# CITY OF ALBUQUERQUE

Re: Office / Warehouse, 3711 Paseo del Norte Blvd NE, Traffic Circulation Layout  
Architect's Stamp dated 4-3-07 (C17-D19)

**Re: 3711 Paseo Del Norte NE, Lot F-1-A Lands of Springer, Traffic  
Circulation Layout, Architect's Stamp dated ~~XXXXXX~~ (C17-D19)**  
4-3-07

TCL-1

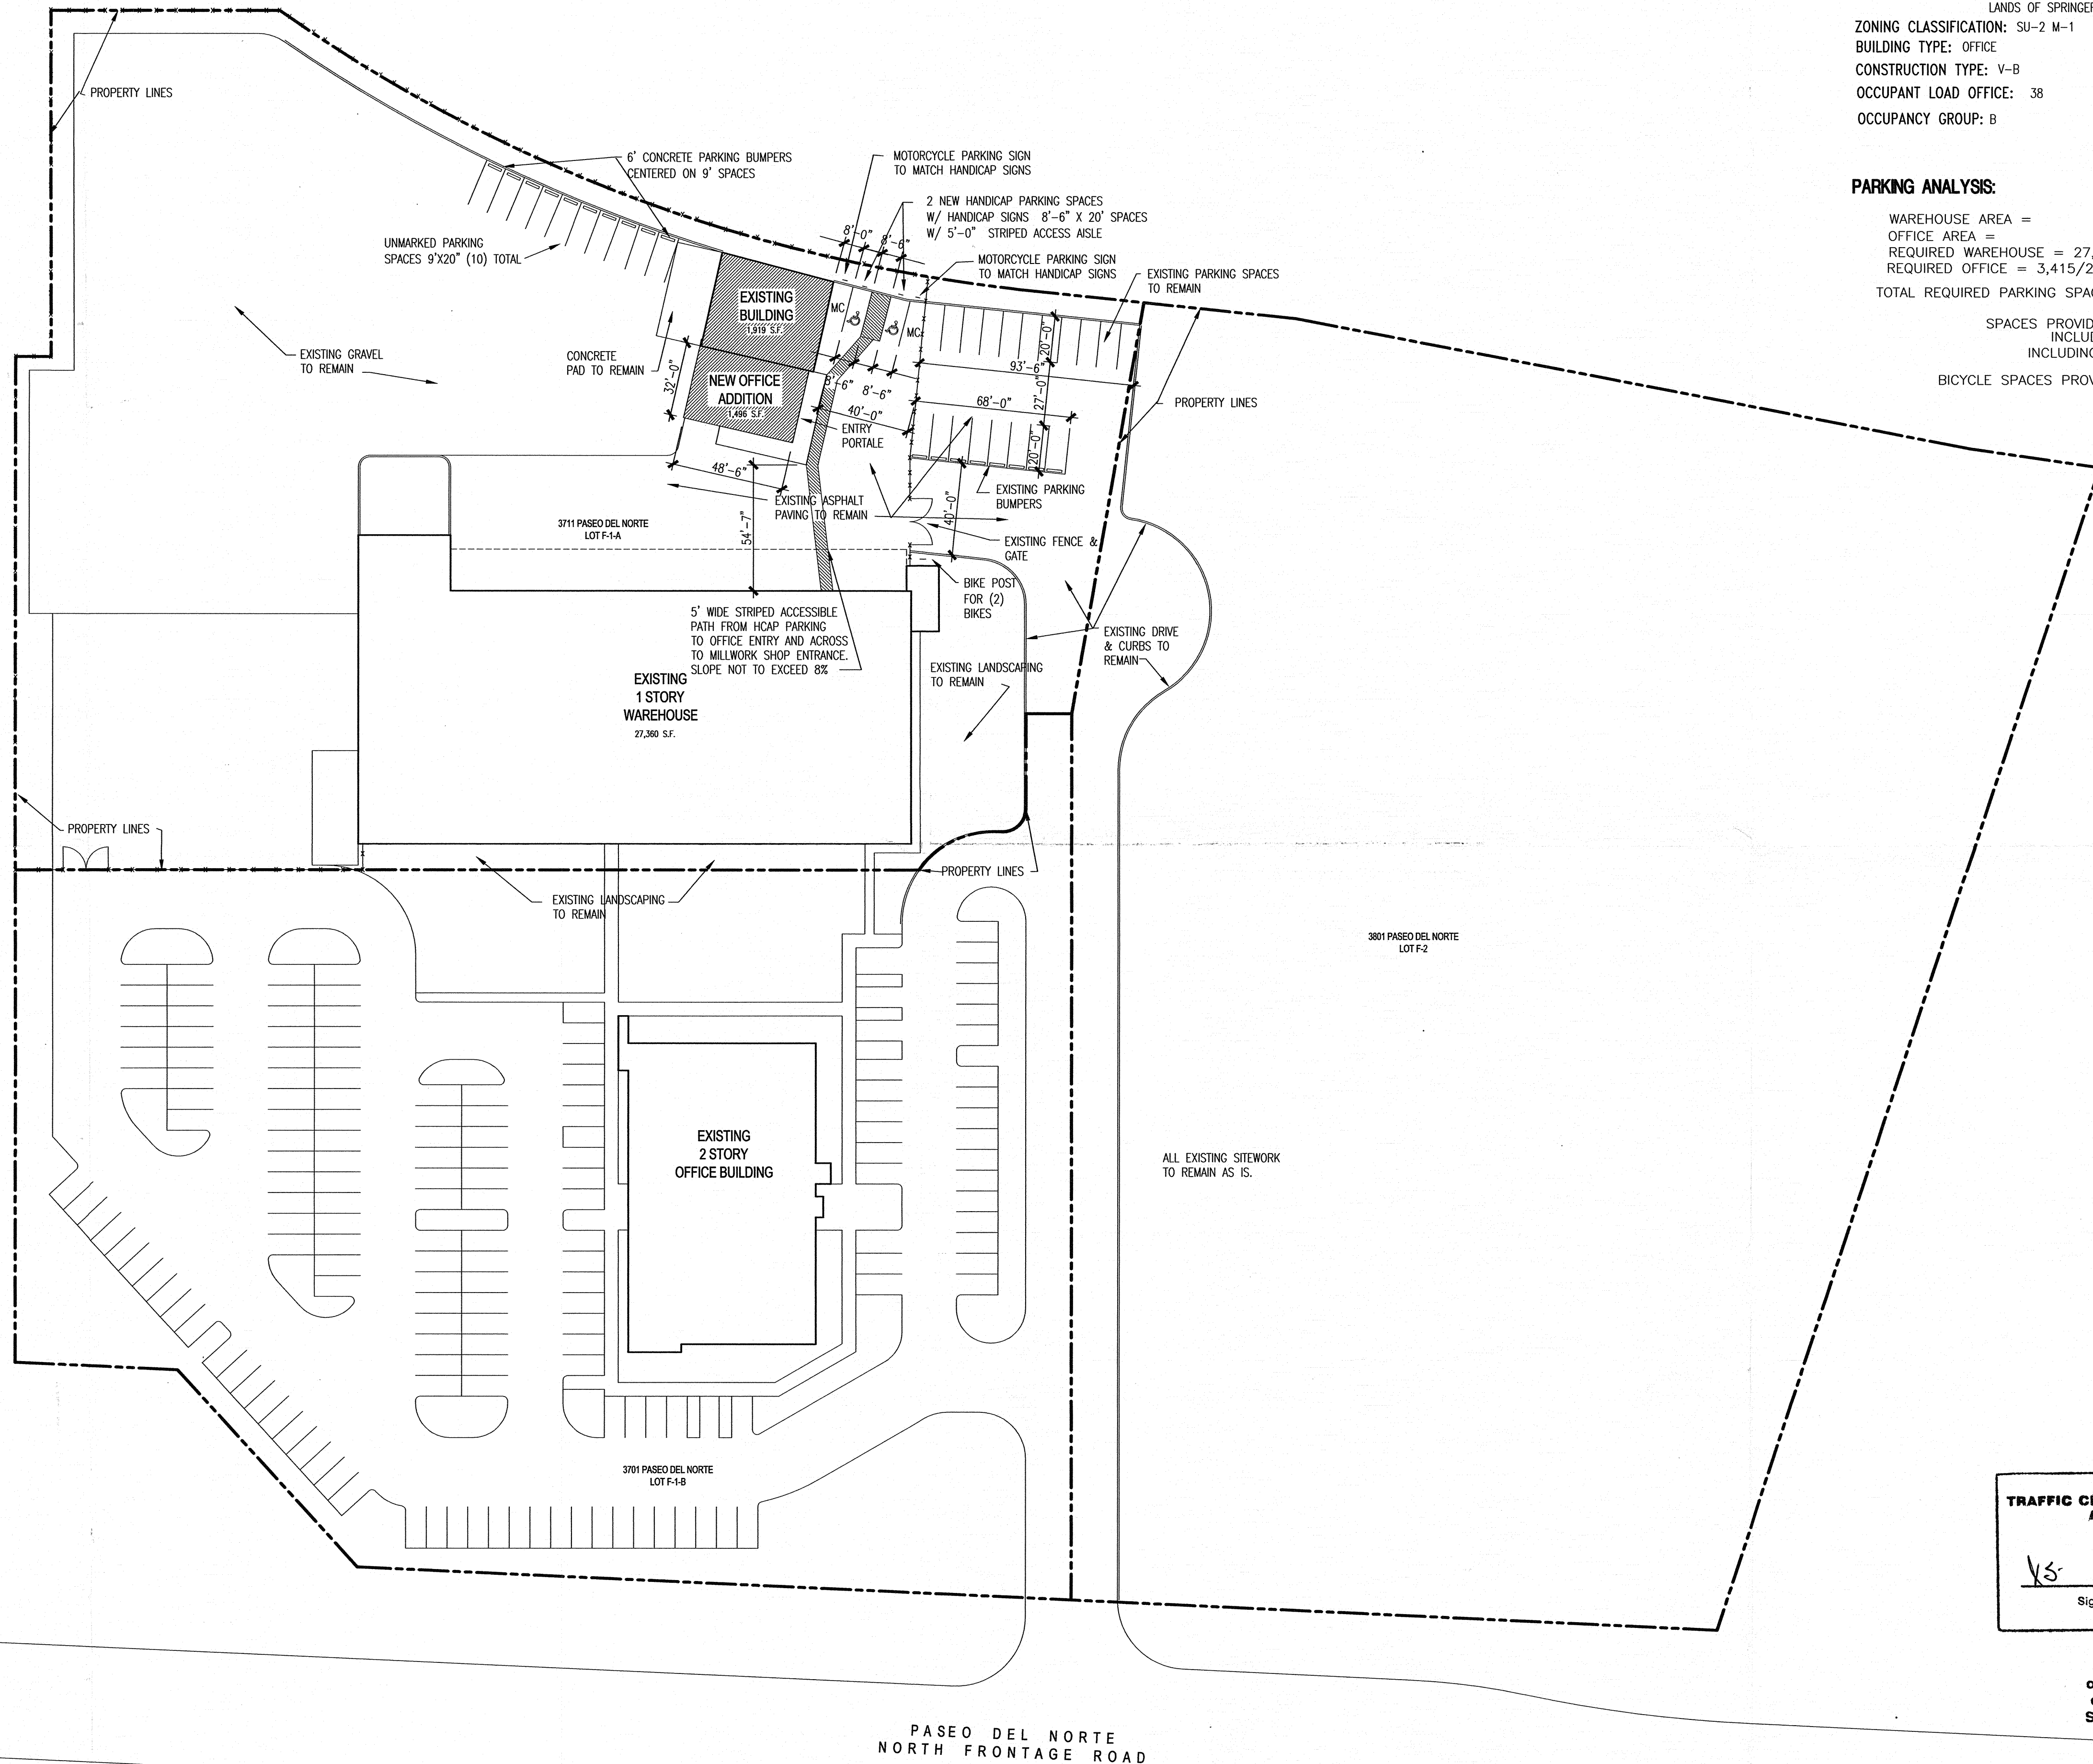
1. Sign and date the plans.
